CHAPTER 6   DESIGN REVIEW OF CHENNAI PERIPHERAL RING ROAD (CPRR)

6.1.1   Objectives and Scope of Design Review of CPRR

In order to confirm the reasonability of providing the Japan International Coordination Agency (JICA) Loan to the CPRR Project, the review is undertaken on the design made in the Detailed Project Report (DPR).

Source: JICA Study Team based on DPR Drawing（14518/E/IC/NH5/DD001: SH-2 OF 3）
Figure 6.4.27   Cross Section of Reinforced Earth Wall (IC)

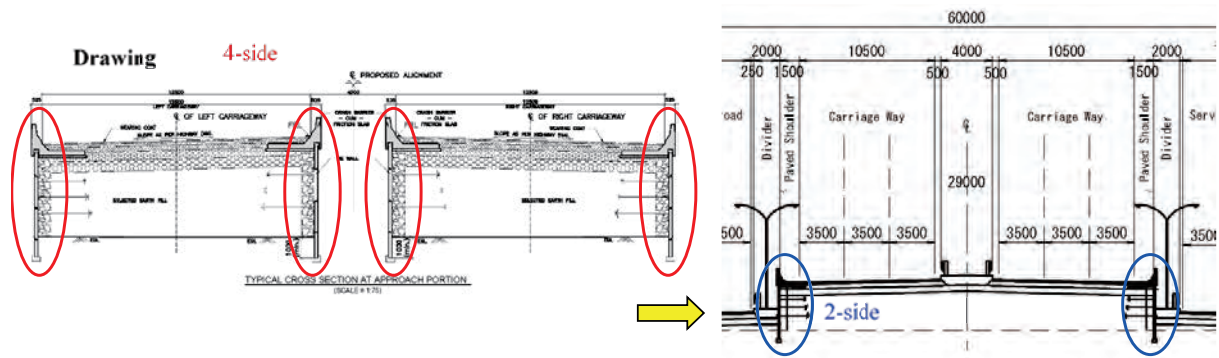
➢   The distance between the northbound and southbound lanes is about 4 m. If the reinforced earth wall is arranged on the back of the bridge end, two sides can be constructed, and the structure is economical. Therefore, a plan for reinforced earth wall of IC with two side construction is proposed.

Figure 6.5.17   Proposed Cantilever Length of Slab

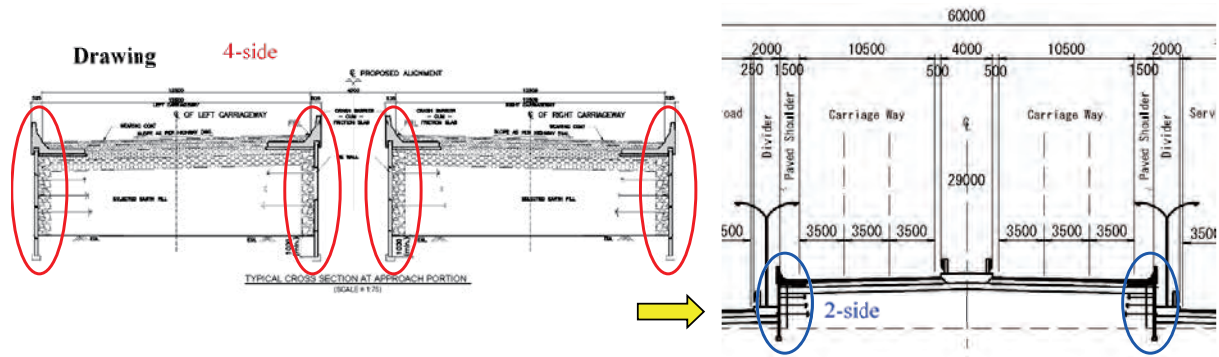
The deck cantilever is about 4.5 m. Although this design is valid in HMPD, it is preferable not to set the length to maximum considering deterioration and unexpected loadings. Adjustment of edge curvature or box girder width in order to attain the preferable length is advised.
